UN#10-122

**Response to NRC RAI No. 101
Questions 02.04.12-9, 02.04.12-10 and 02.04.12-11,**

Calvert Cliffs Nuclear Power Plant Unit 3

**Update of COLA Part 2, FSAR
to incorporate the new Groundwater Model**

Figure 2.3-80—Modeled Post-Construction Elevation to Surficial Aquifer Water Table Around Power Block 3

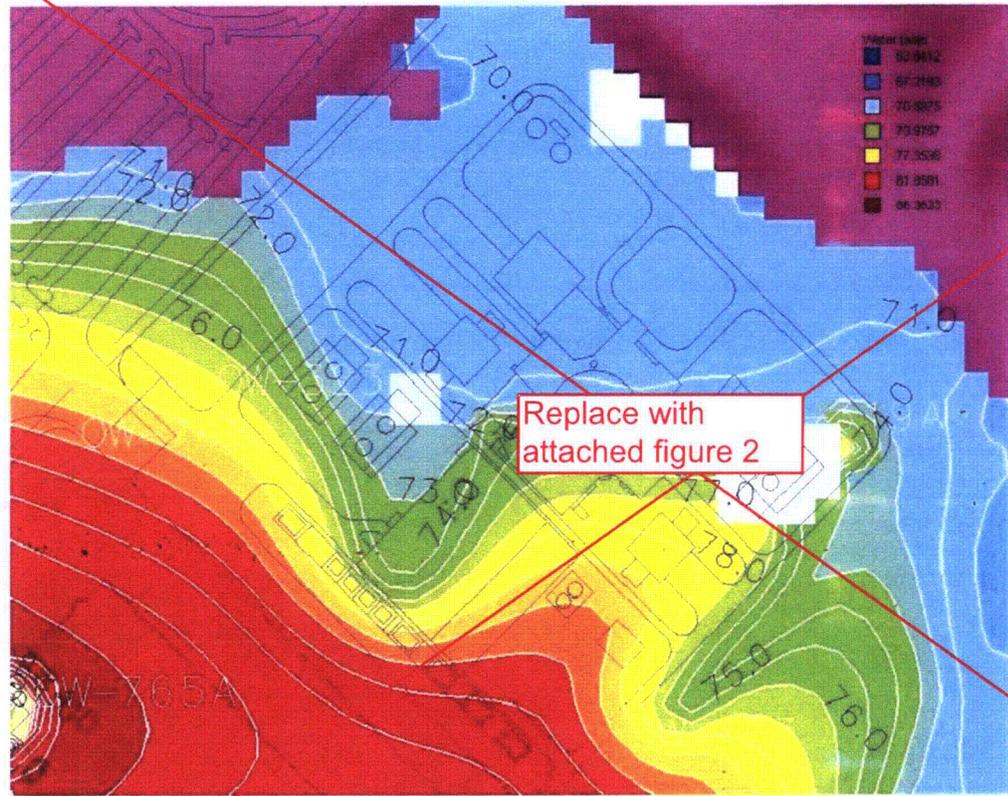
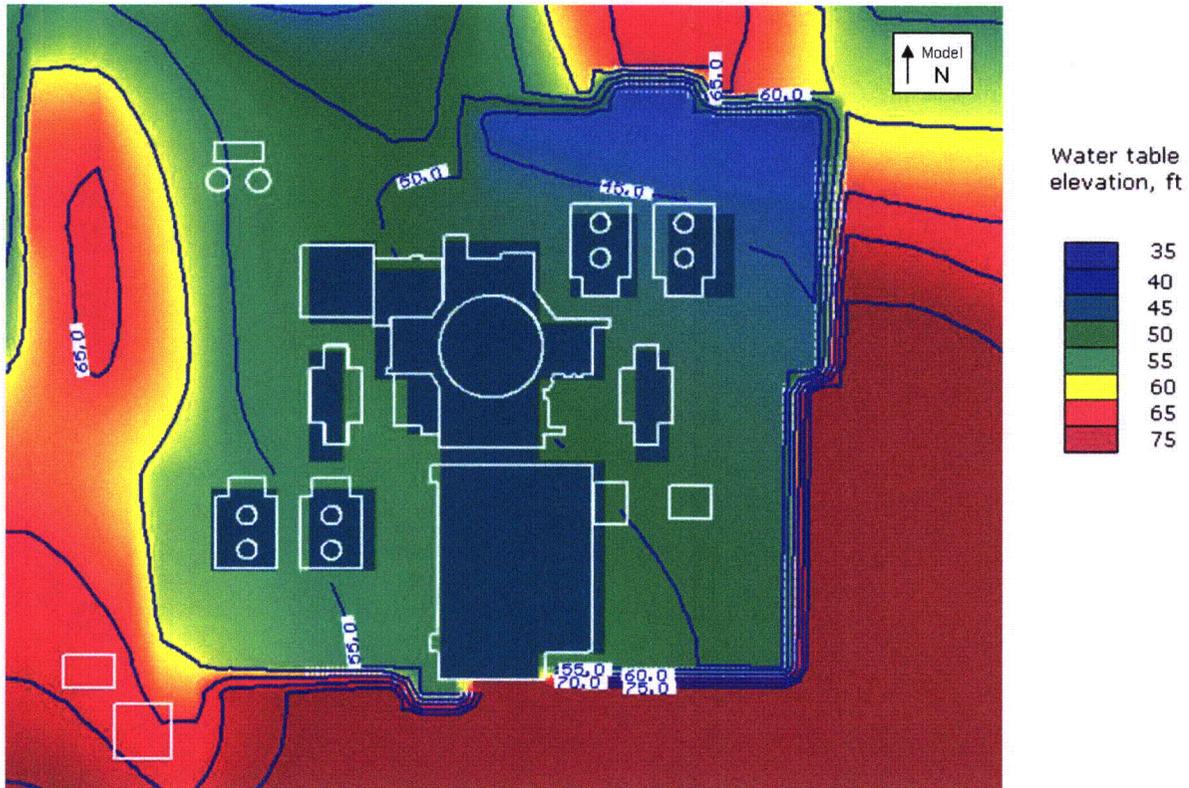
Replace with attached figure 2

Replacement ER Figure 2.3-80
